ADDENDUM NUMBER: #1

Project Name: PSJA ISD BUELL CENTRAL HS
& CLOVER ELEMENTARY
RE-ROOFING BID #18-19-054

Milnet Project No.: 219005

R1.02

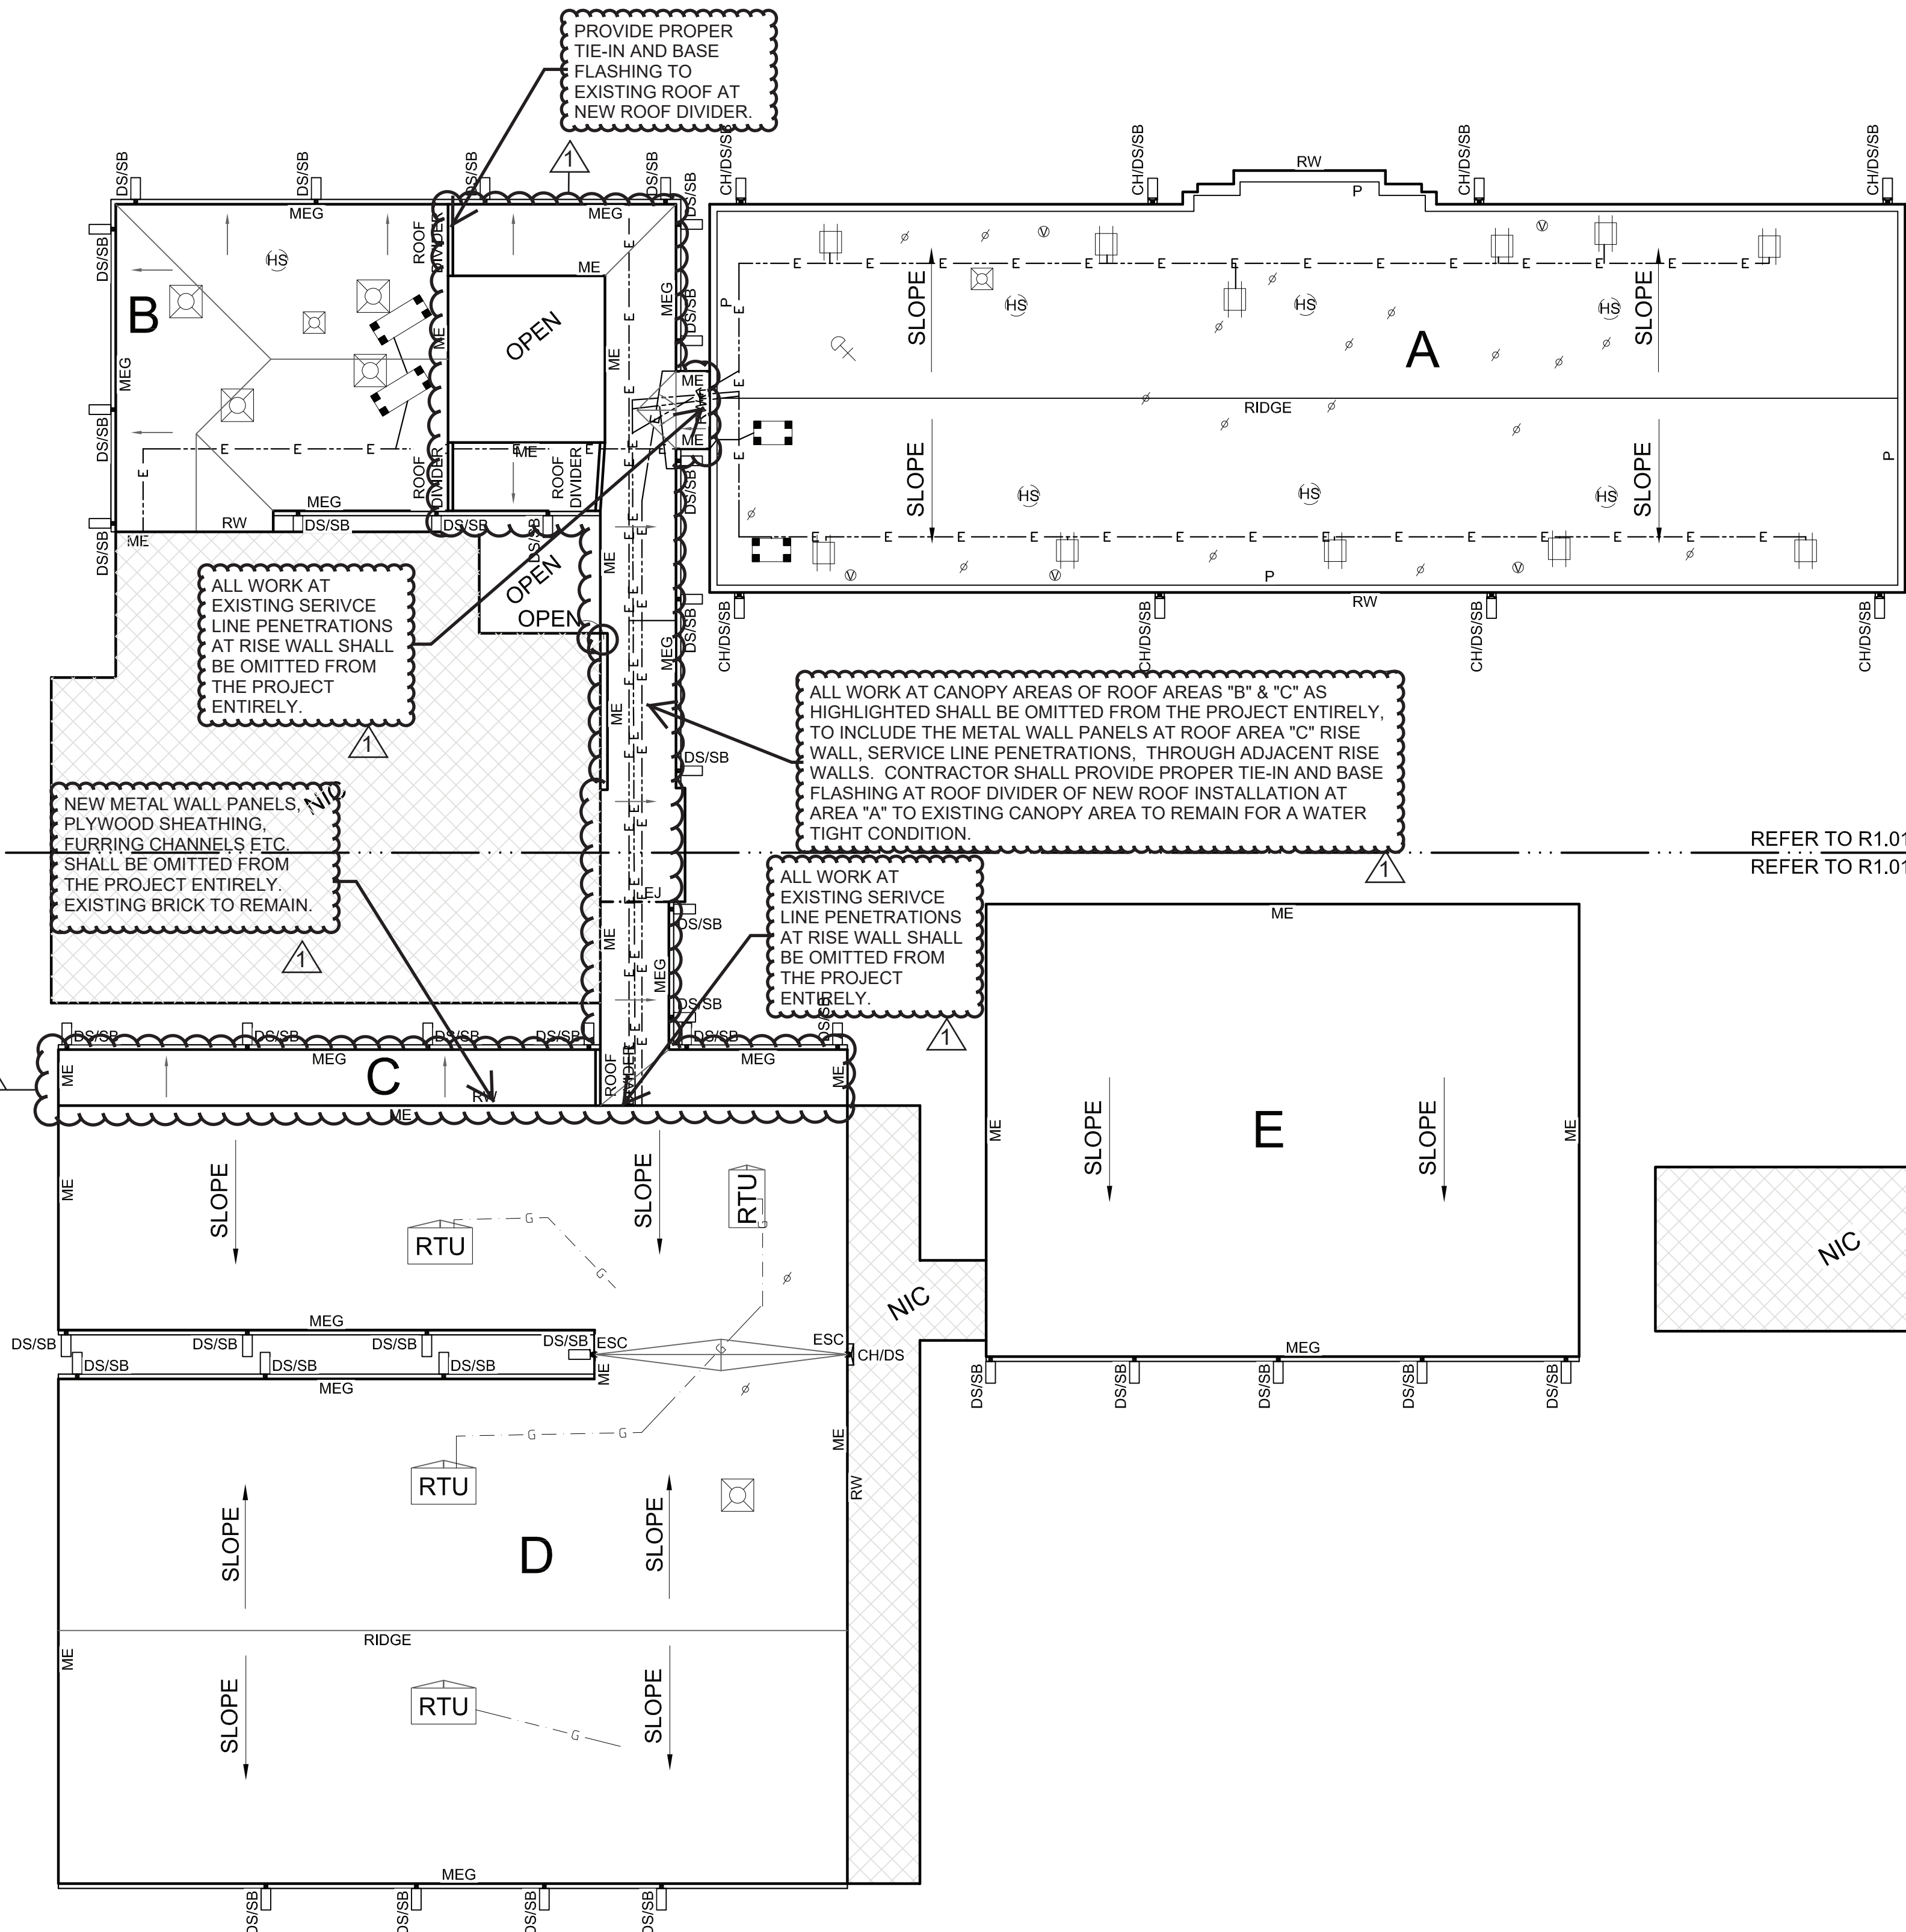
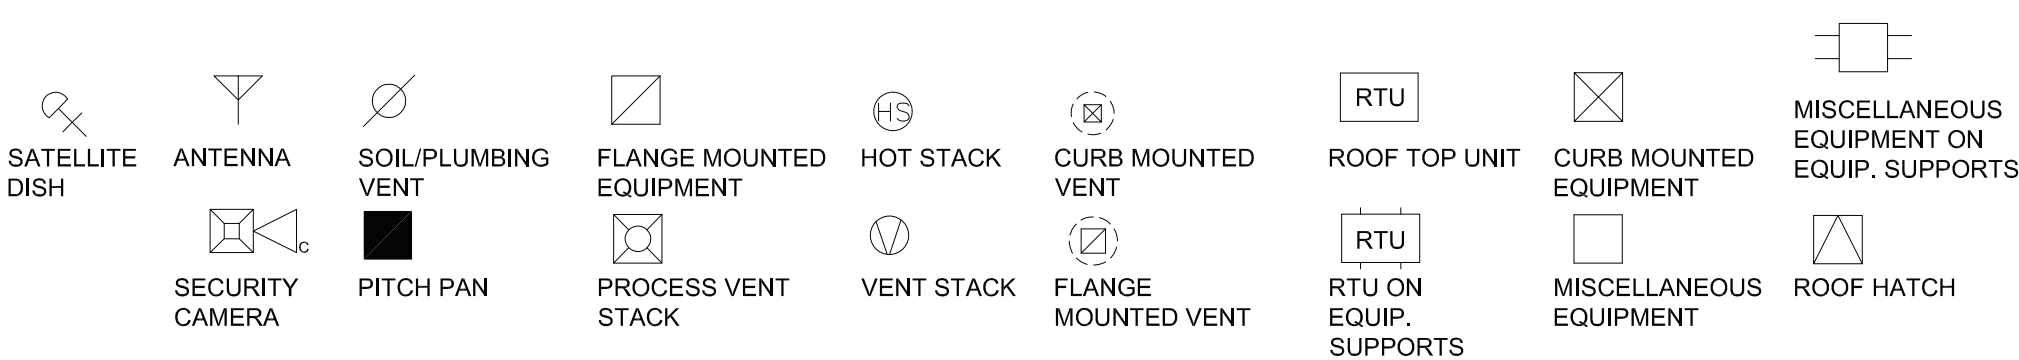
1.02 **Clarification:** Scope of work on canopy labeled “C” shall be omitted from project, existing canopies are to remain. See attached R1.02 for additional information, revised R1.02 to replace sheet in contract documents.
